Village of Morton Grove  
**PLAN COMMISSION MEETING**

To: Chairperson Kintner and Members of the Plan Commission

Re: Plan Commission Case PC 25-07

Re: Appearance Commission Case AC 25-08

***Detail of Proposed Outdoor Seating Area***

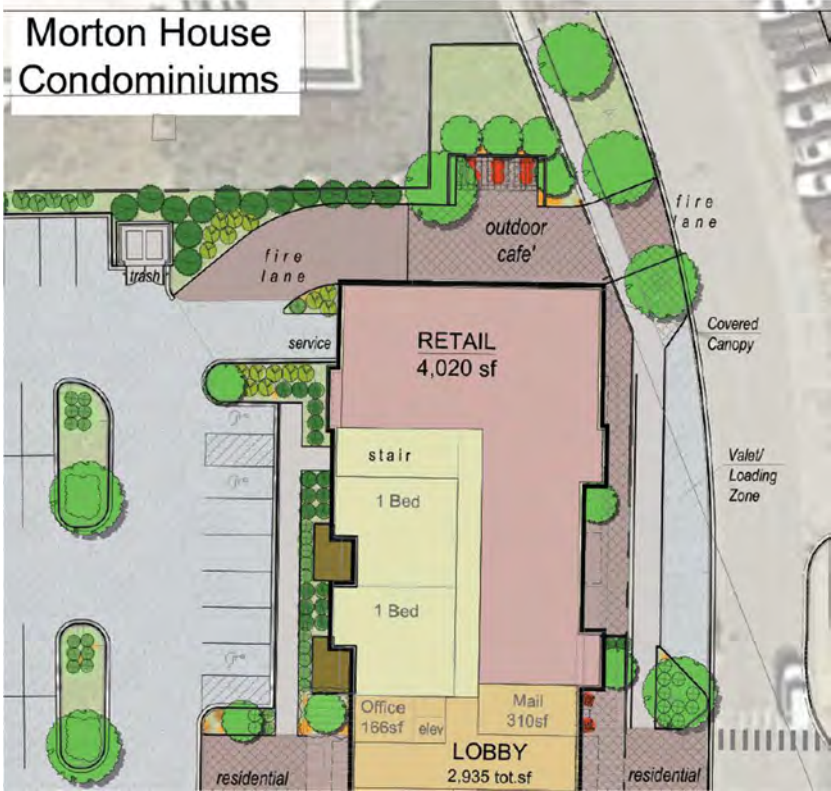
It is not clear whether portions of the Lehigh Avenue frontage would be used for outdoor seating, or if that would be restricted to the seating area identified along the northern edge of the property. While public seating benches may be desirable within the streetscape area, any seating within the Lehigh Avenue right of way intended for dedicated use by business patrons or residents within the development would require a license agreement with the Village. The Village may impose additional requirements to mitigate liability for private use of Village-owned property and the final outdoor seating area plan will be subject to approval by the Village Administrator.

***The applicant should confirm the potential locations of future outdoor seating and speak to what kind of protections and screening will be provided for diners within the outdoor seating areas in the Lehigh Avenue public right of way.***

Staff recommends that as a condition of approval, all final outdoor seating area plans, including screening and furniture specifications, must be reviewed and approved by the Appearance Commission Chairperson. The Chairperson may require full Appearance Commission review if the quality and design of the outdoor seating areas is not in keeping with the quality and design of the overall development. Language regarding planter box maintenance is also included as a condition.

*Revised site plan (TOP); Outdated site plan in civil drawings (BOTTOM)*

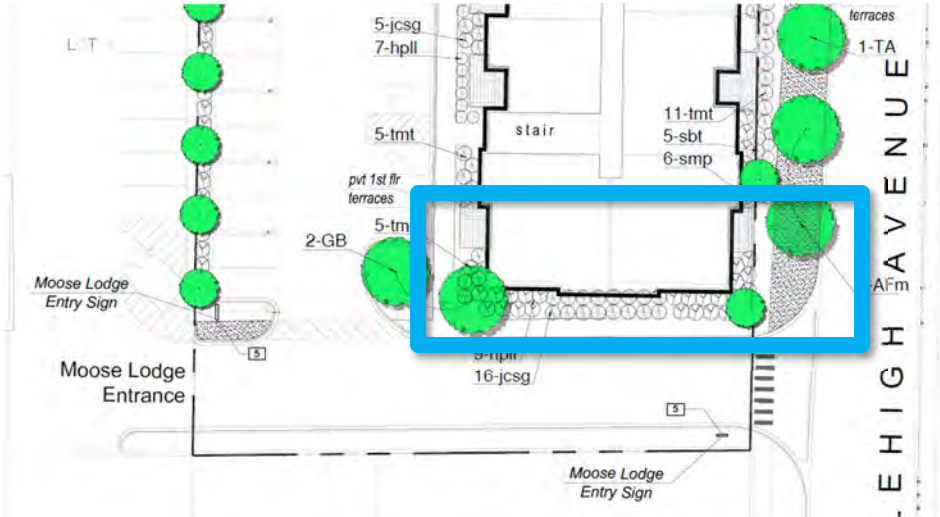
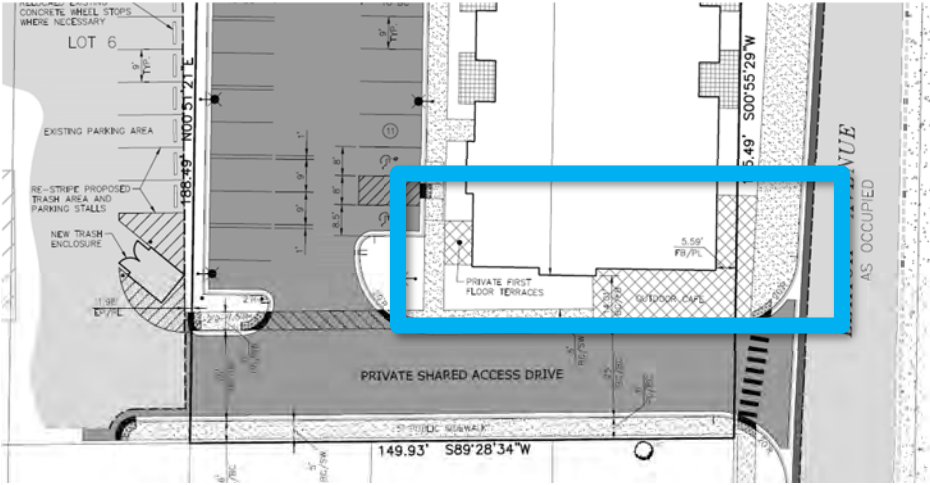
The site plan and landscape plan and related architectural drawings were revised by the applicant to eliminate a retail space and related outdoor seating area at the south end of the building. Staff has request revised civil drawings that replace the previous, outdated building extent and landscaping.

The sidewalk on the south side of the access drive along the south property line was also removed in the current application.

**Native Plantings**

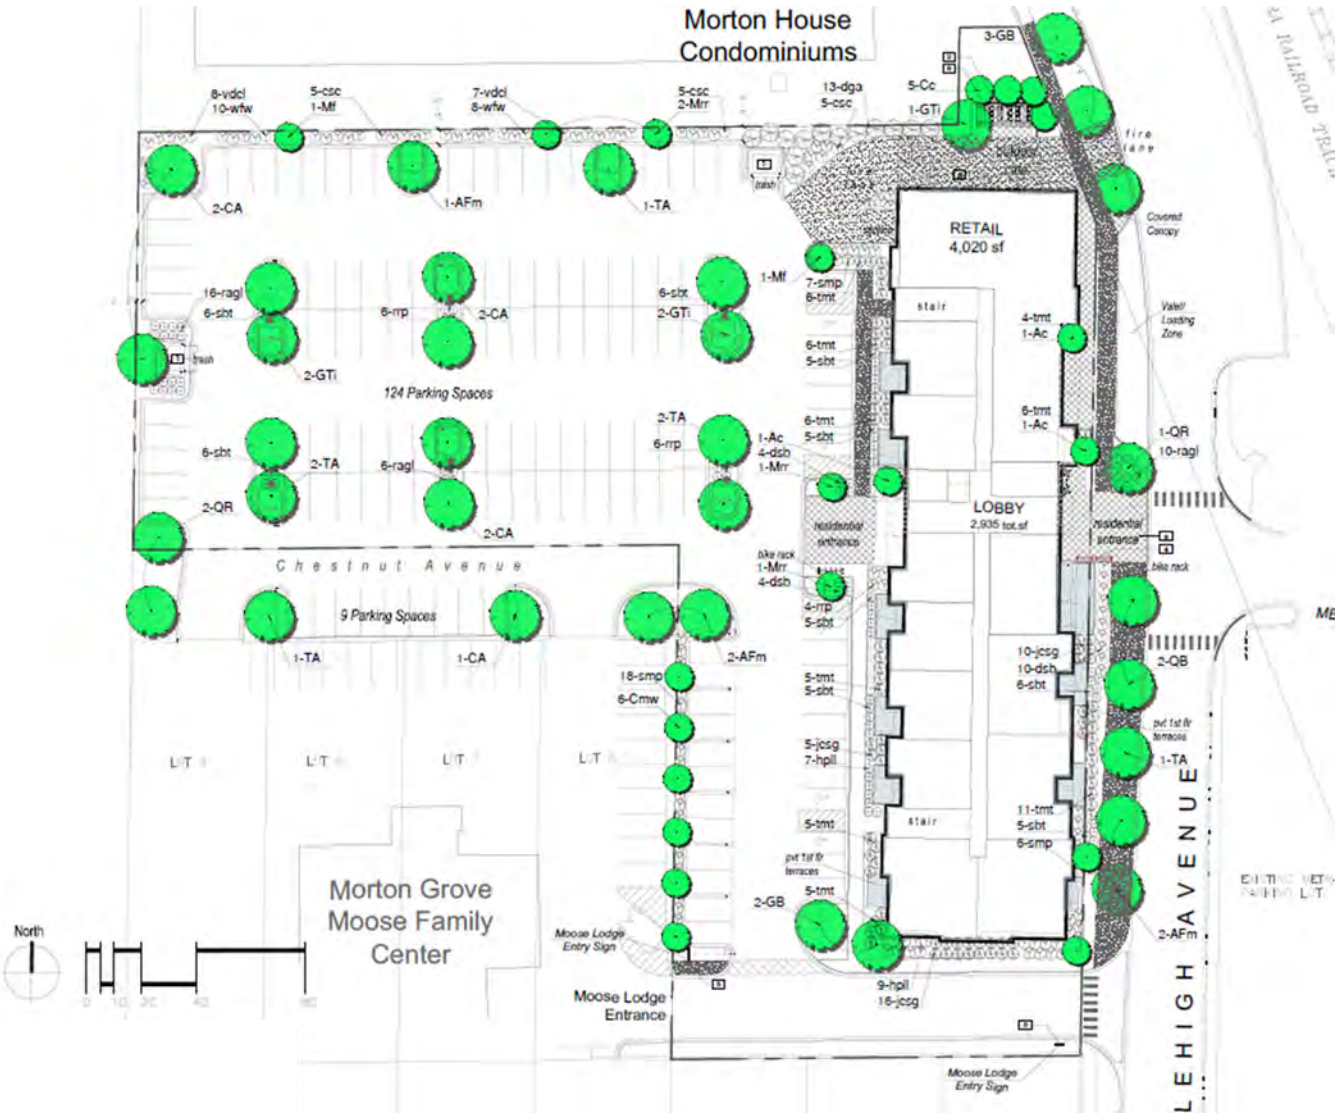
With respect to the proposed waiver to allow no landscaping or alternative screening along lot lines abutting forest preserve property, staff recommends reducing the minimum screening height to three feet, where five feet are typically required by Code, or as otherwise recommended by Forest Preserve District staff. Staff is concerned that headlights from vehicles in the parking and driveway areas will be disturbing to these biologically sensitive areas and should be shielded. The Appearance Commission supported a waiver to allow for the landscape bed along the west lot line to maintain the proposed narrow width. **However, the Appearance Commission recommended as a condition of approval that the developer install fencing or year-round opaque screening a minimum of three feet in height. The Appearance Commission also recommended that any landscape installation along lot lines abutting the forest preserves must be limited to native species.**

Due to the subject property's proximity to natural areas, staff recommends as a condition of Appearance Certificate approval that the submitted landscape plan include only species that are not invasive or undesirable. Staff reviewed the proposed plant list against the Northwest Illinois Forestry Association invasive plants list and did not identify any invasive species. Staff has concerns regarding the proposed use of "Grow-low Sumac." The same plant has been used in several projects in the Village and some larger installations such as in parking lot islands at the Sawmill Station retail center have experienced die-offs due to a fungus. **In discussion with the Appearance Commission, the applicant agreed to substitute another non-invasive groundcover species for the "Grow-low Sumac."**

Revised site plan (TOP); Outdated site plan in civil drawings (BOTTOM)

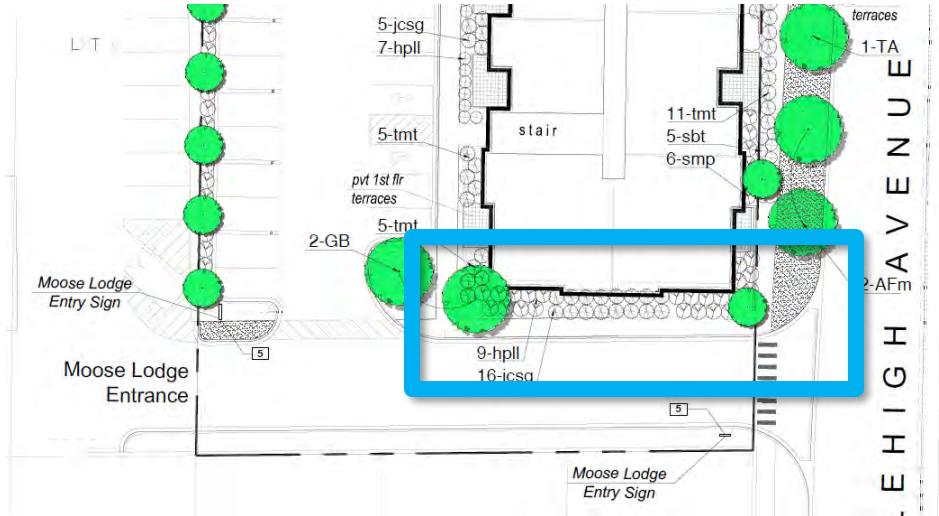
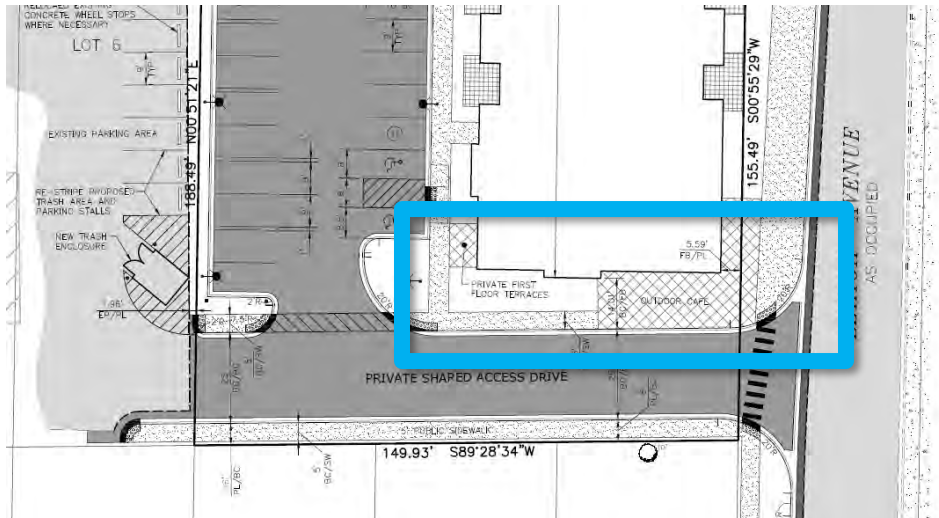
The site plan and landscape plan and related architectural drawings were revised by the applicant to eliminate a retail space and related outdoor seating area at the south end of the building. Staff has request revised civil drawings that replace the previous, outdated building extent and landscaping.

The sidewalk on the south side of the access drive along the south property line was also removed in the current application.

Detail of Proposed Outdoor Seating Area

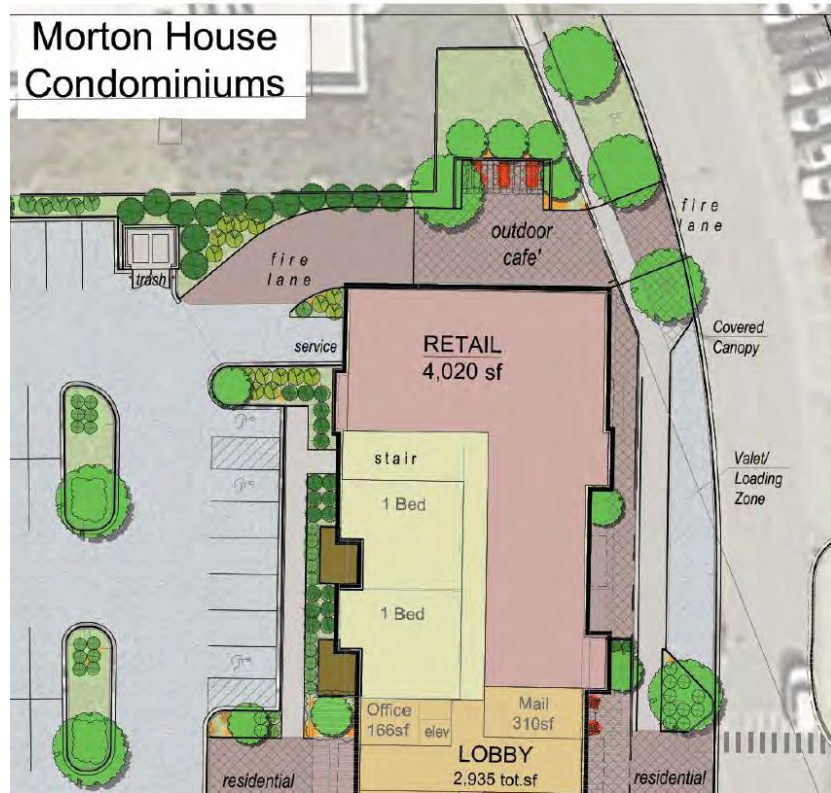
Per Section 12-5-5:C, if outdoor seating areas are in excess of 100 square feet, adequate landscaping and screening must be provided, subject to review and approval by the Appearance Commission. Outdoor seating area requirements are outlined in the following table.

### Signage

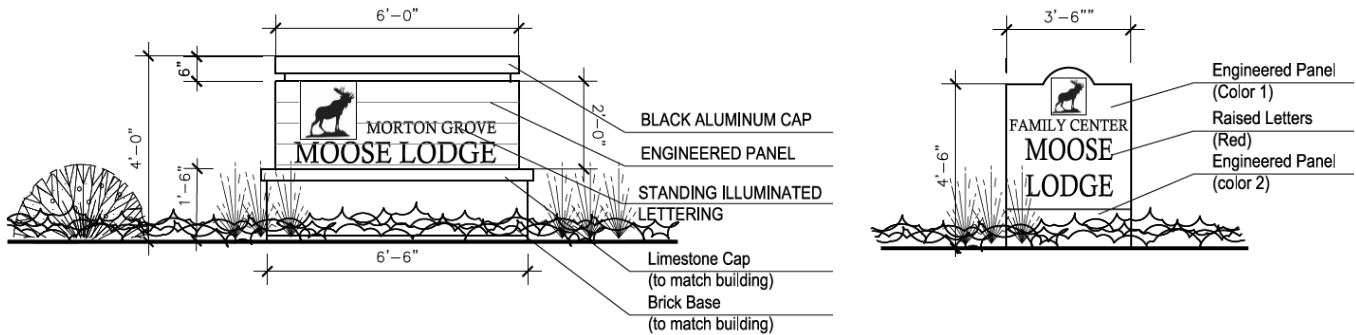
Because no specific tenants are being proposed at this time, a signage plan for the development was not submitted to the Appearance Commission for review. All signage is expected to comply with all requirements of Chapter 10-10 unless waivers are requested and approved by the Appearance Commission at a later date. The applicant should speak to the types of tenant and directional signage they anticipate and how the signage will be designed to be cohesive and complementary to the overall development.

In order to maintain a high quality “downtown” feel, staff recommends conditions of approval that will enhance the overall quality of signage and attention-seeking ornamentation serving the development:

- 1) Sign colors shall blend with the building and storefront colors through use of complementary color ranges, or as otherwise approved by the Appearance Commission Chairperson.
- 2) Any portable signage shall be permitted pursuant to Section 10-10-8:E, except that the signage frame and base shall be constructed primarily of metal or wood, or as otherwise authorized by the Village Administrator.
- 3) Illuminated signage and other illuminating features on the property may not exceed 5,000K (degrees Kelvin).
